Bid Package 7.20 Curbs Gutters and Sidewalk – ADDENDUM NO. 5 (3/12/10)

FOR: **CHINATOWN/ NORTH BEACH CAMPUS, Main Building and Annex Building CCSF Project 107A**

Bid Package 7.20 Concrete Curb, Gutter, Sidewalk, Striping and Graphics ADDENDUM #5

SIDEWALK DETAIL
SCALE: NONE

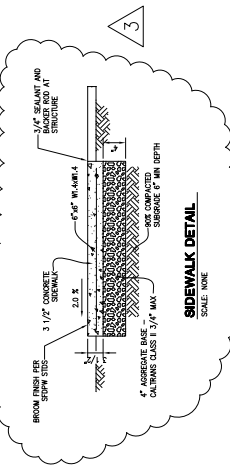
1. Base conditions under new sidewalks and pavers (e.g., class II A.B., sand, etc). The Annex Drawing A4.02 calls for "traffic engineered base", but it is not defined anywhere.
2. Per Annex sheet A2.01, The paving section for the asphalt paving on ILS Lane.
3. Per Annex sheet A2.01, Paving sections of asphalt and concrete to be removed on ILS Lane.

1. Per detail C-3.01, please provide Base conditions under new sidewalks.
2. Per detail D-1.01, please provide paving section of asphalt and concrete to be removed on ILS Lane.

1. The sidewalk detail on C-4.01 has been revised to show 4-inches of aggregate base over 6-inches of compacted subgrade. Aggregate base is already specified in Section 02705.
2. A paver detail has been added to C-4.01.
3. Drawing D-1.01 calls out the removal of asphalt on ILS Lane. Drawing D-1.01 has been revised to remove the demolition hatching from the existing stoops.

1. See 10/A8.03. The sidewalk detail on C-3.01 has been revised to show 4-inches of aggregate base over 6-inches of compacted subgrade.
2. The extent of demolition at ILS Lane is to be show in the LOT 5 drawings.

1. ANNEX - a new curb and gutter is required on both Washington Street and Columbus Avenue.
2. MAIN and ANNEX - the sidewalk detail on C-3.01 (MAIN) and C-4.01 (ANNEX) was revised as part of RFI 234. This new detail should be used. Reinforcement, aggregate base, and compacted subgrade are required for the new sidewalks.

**RFI 643
SK 1 of 1
3/10/10
REF. A2.01**

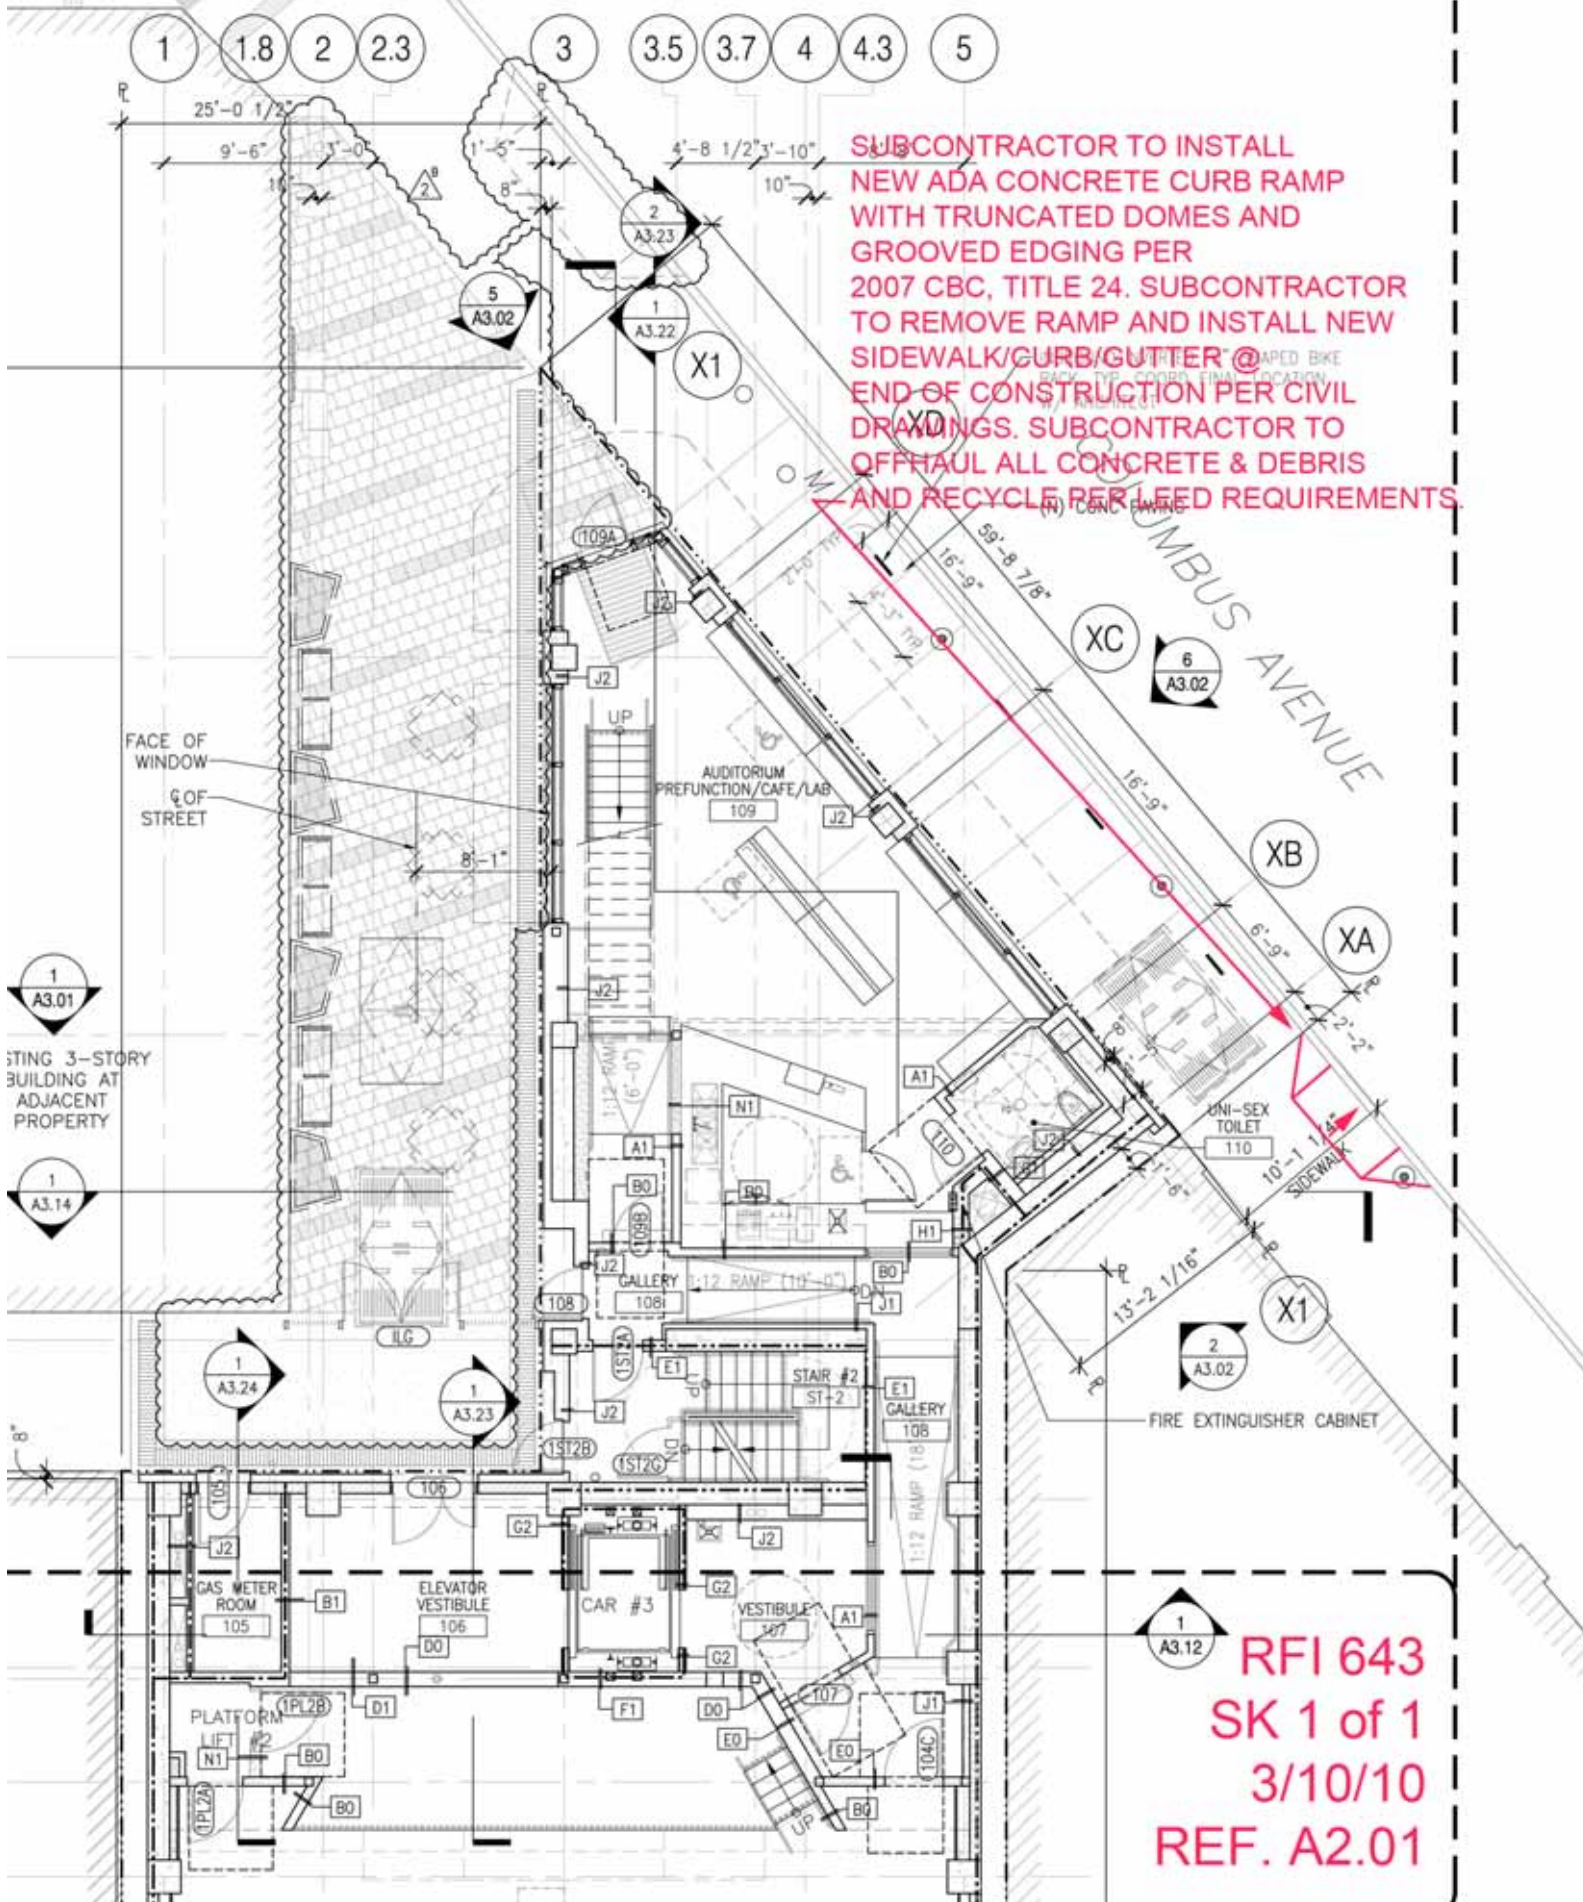
28. Subcontractor to provide and install new curb ramp at Columbus Ave sidewalk per RFI 643response attached, for pedestrian access during construction. Subcontractor to remove curb ramp at the end of construction, when approved by the Contractor, and replace with new sidewalk and curb/gutter per final civil drawings. Subcontractor to offhaul all concrete and debris per LEED requirements.

See attached sketch 1 of 1 for new ADA curb ramp along Columbus Ave. Reference drawing A2.01, Annex

SUBCONTRACTOR TO INSTALL NEW ADA CONCRETE CURB RAMP WITH TRUNCATED DOMES AND GROOVED EDGING PER 2007 CBC, TITLE 24. SUBCONTRACTOR TO REMOVE RAMP AND INSTALL NEW SIDEWALK/CURB/GUTTER @ END OF CONSTRUCTION PER CIVIL DRAWINGS. SUBCONTRACTOR TO OFFHAUL ALL CONCRETE & DEBRIS AND RECYCLE PER LEED REQUIREMENTS.
